MONTGOMERY COUNTY HISTORIC PRESERVATION COMMISSION
STAFF REPORT

Address:	5810 Connecticut Ave., Chevy Chase	Meeting Date:	07/26/17
Resource:	Outstanding Resource Chevy Chase Village Historic District	Report Date:	07/19/17
Applicant:	Dean & Tracy D'Angelo	Public Notice:	07/12/17
Review:	HAWP	Tax Credit:	Partial
Case Number:	35/13-17X	Staff:	Dan Bruechert
Proposal:	Alterations to Accessory Structure

1 NORTH ELEVATION Existing
SCALE: 3/16" = 1'-0"

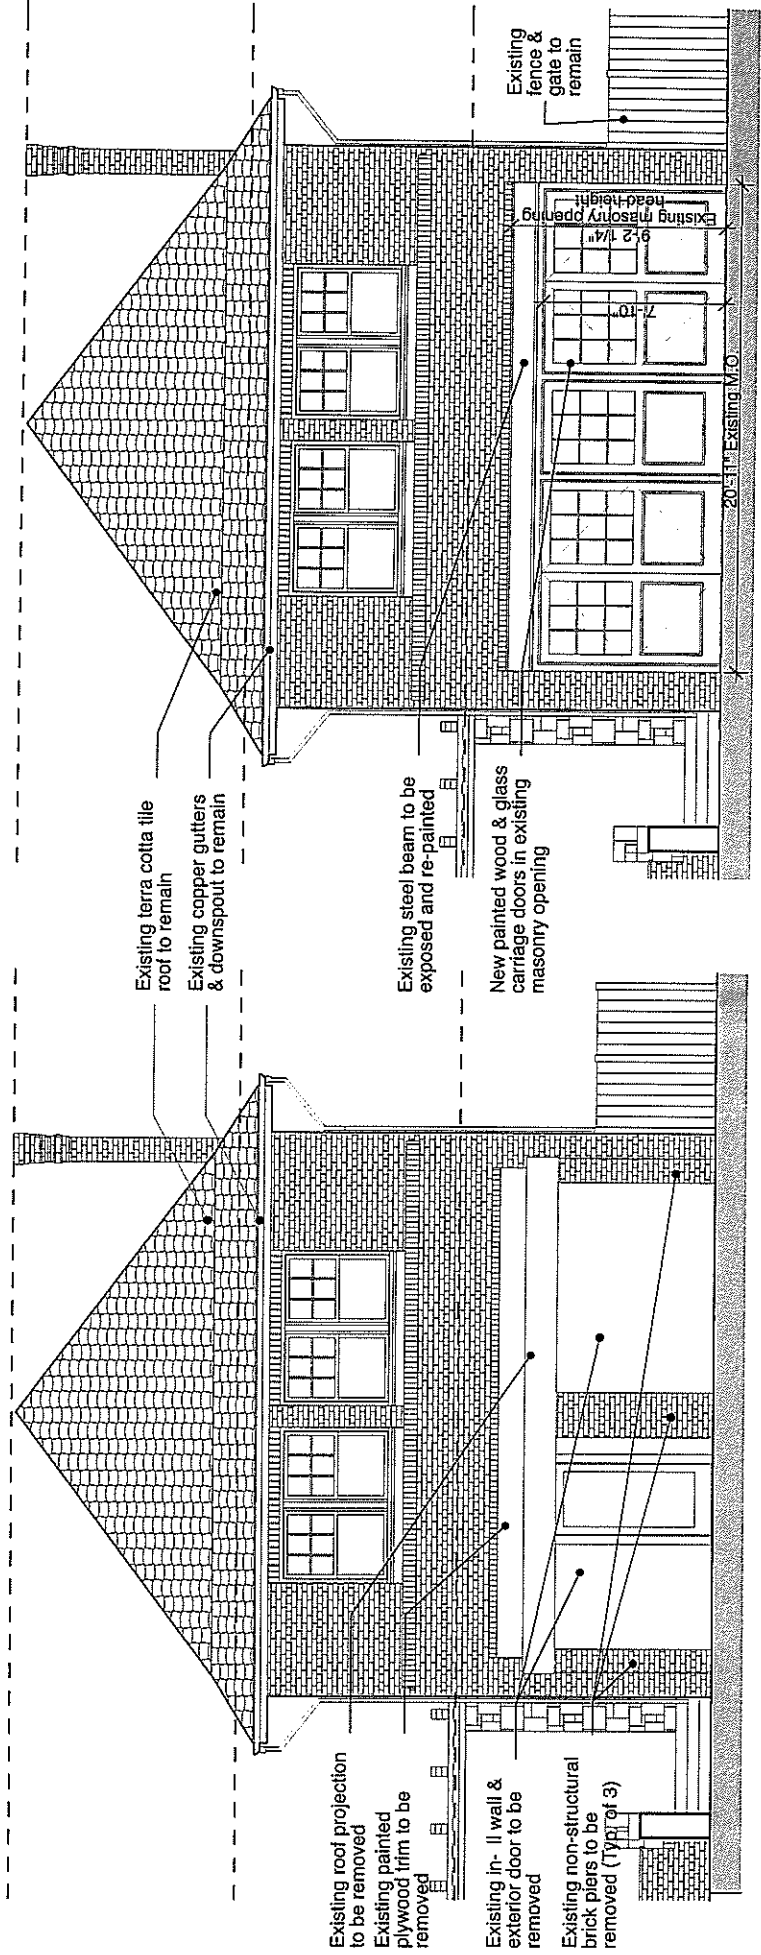
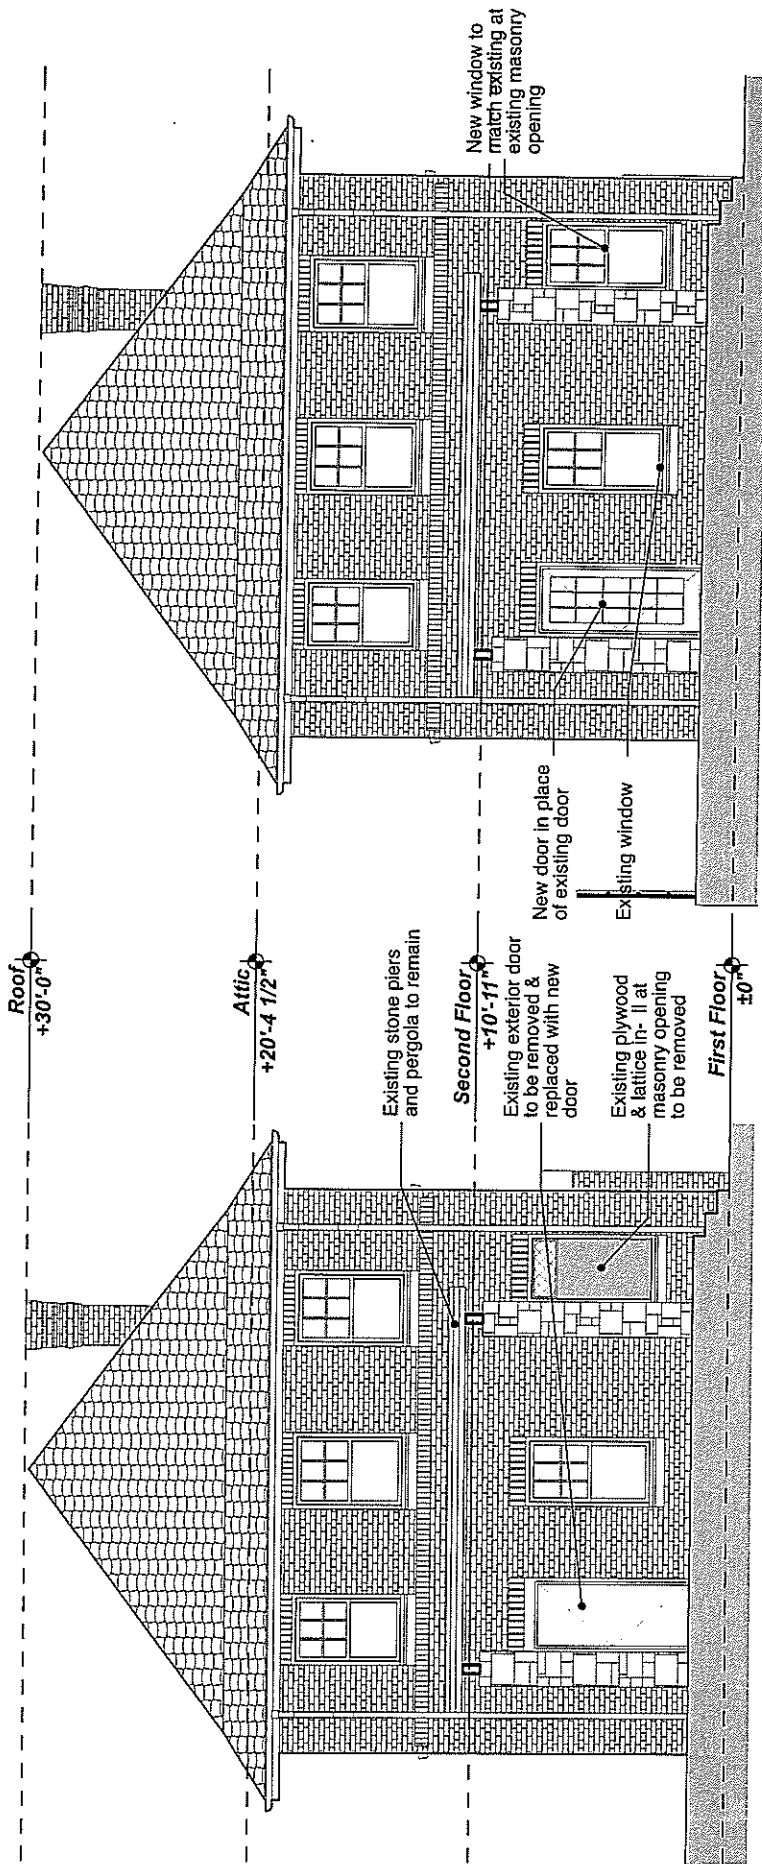
The historic garage door openings on the north elevation were blocked-in and a central pier and door was added. The applicant is proposing to remove the pier, door, and block infill and install half-lite wood and glass garage doors. Garages and accessory structures that are do not share a party wall with the historic house are to be reviewed under lenient scrutiny.

This proposed work will reintroduce a door that is consistent with the character of an early 20th century carriage house/garage. The detailing is in keeping with the character of both the historic house and the garage and is compatible with both 24A-8(b)(2) and the *District Guidelines*. Additionally, the use of wood and glass are historically appropriate materials and Staff supports approval of this proposed work.

EAST ELEVATIONS Existing & Proposed

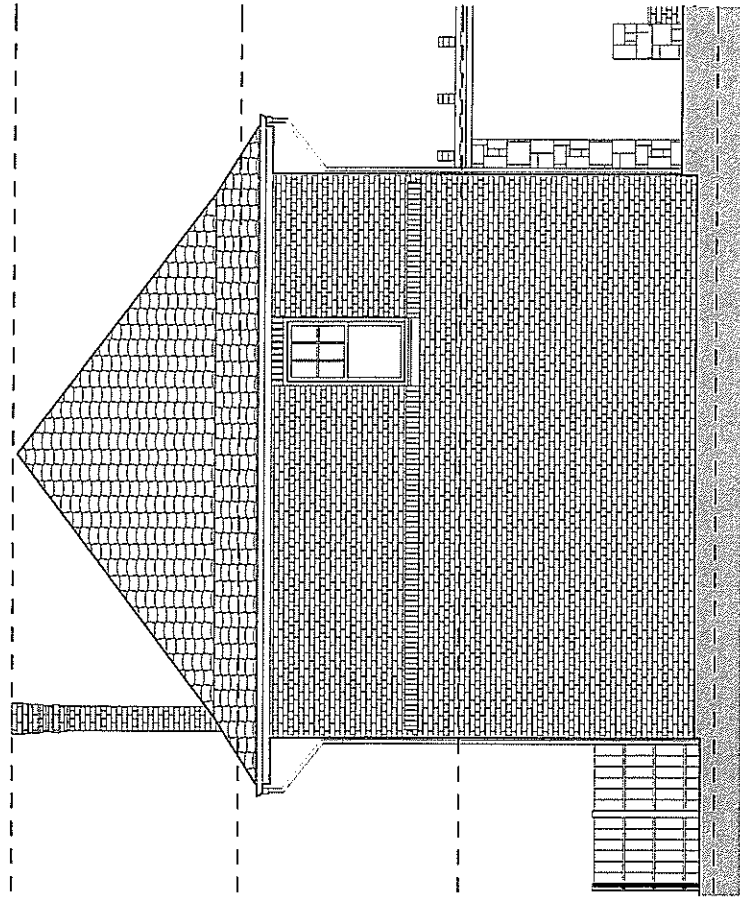
Work proposed for the east elevation consists of removing a non-historic first floor door and removing the in-fill for a first-floor window. The applicant will install a compatibly-designed full-lite glass and wood door and six-over-one true divided lite wood window that matches the design and configuration of the other windows on the elevation. As this is proposed for a secondary elevation to a detached garage, this proposal is to be reviewed under lenient scrutiny. This work will all be completed within the historic garage openings and are an improvement in appearance and should be approved.

WEST ELEVATIONS Existing & Proposed

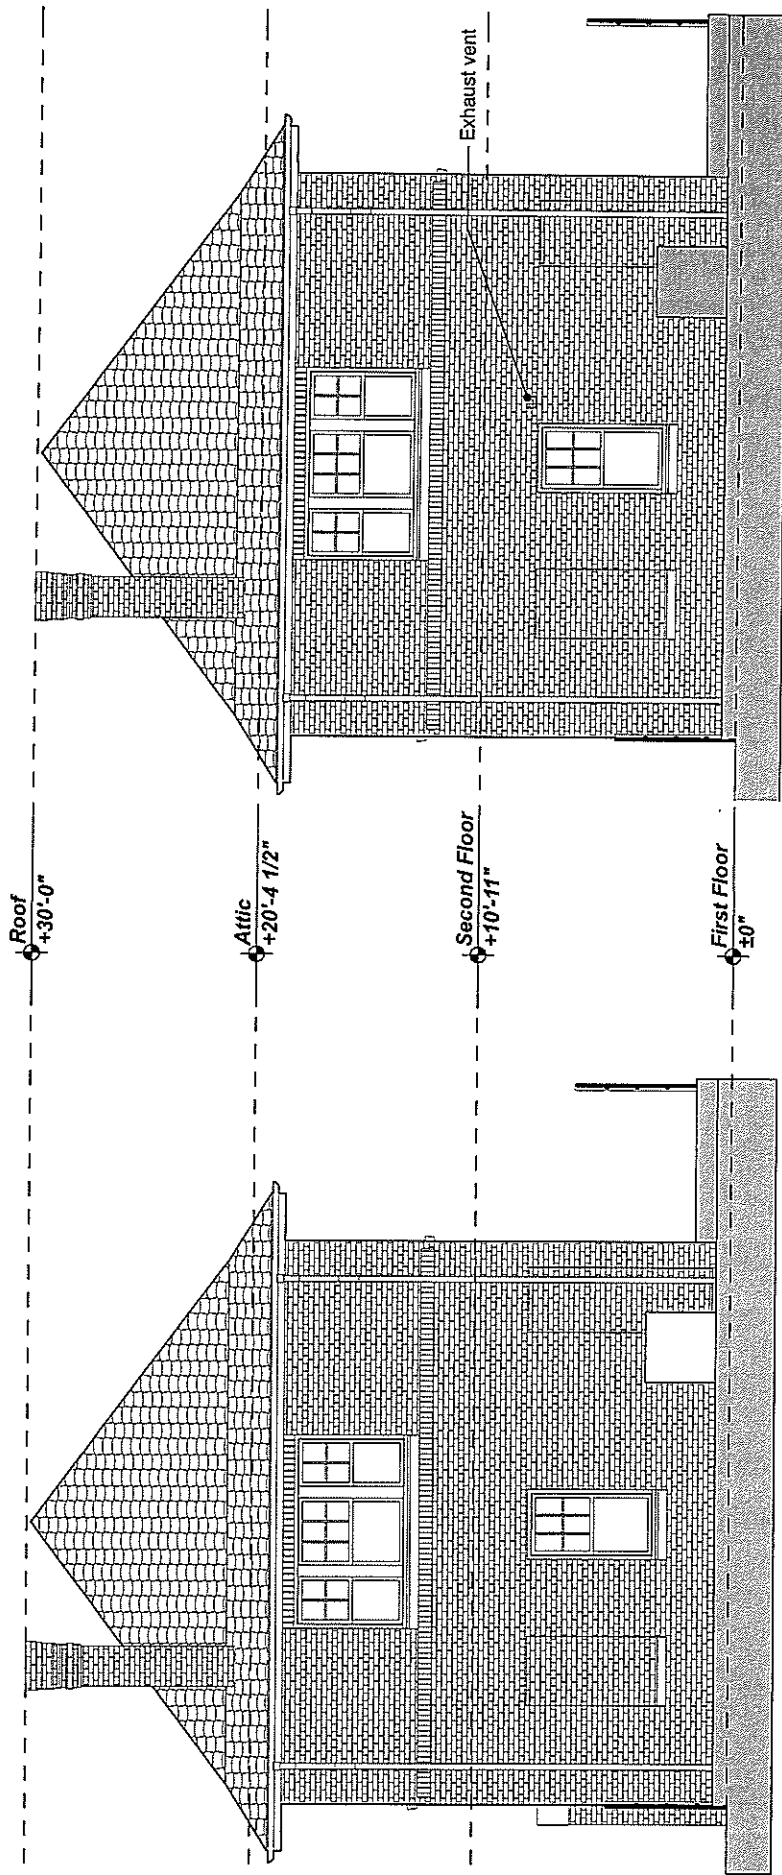
On the west elevation, the applicant is proposing to install an exhaust vent on the first floor. On the south elevation, the applicant is proposing a bathroom vent on the second floor. Both of these alterations are on secondary elevations of a detached garage and are to be reviewed under lenient scrutiny. These changes are necessary for the building's interior rehabilitation and will

have a minor impact on the exterior character of the building and should be approved.
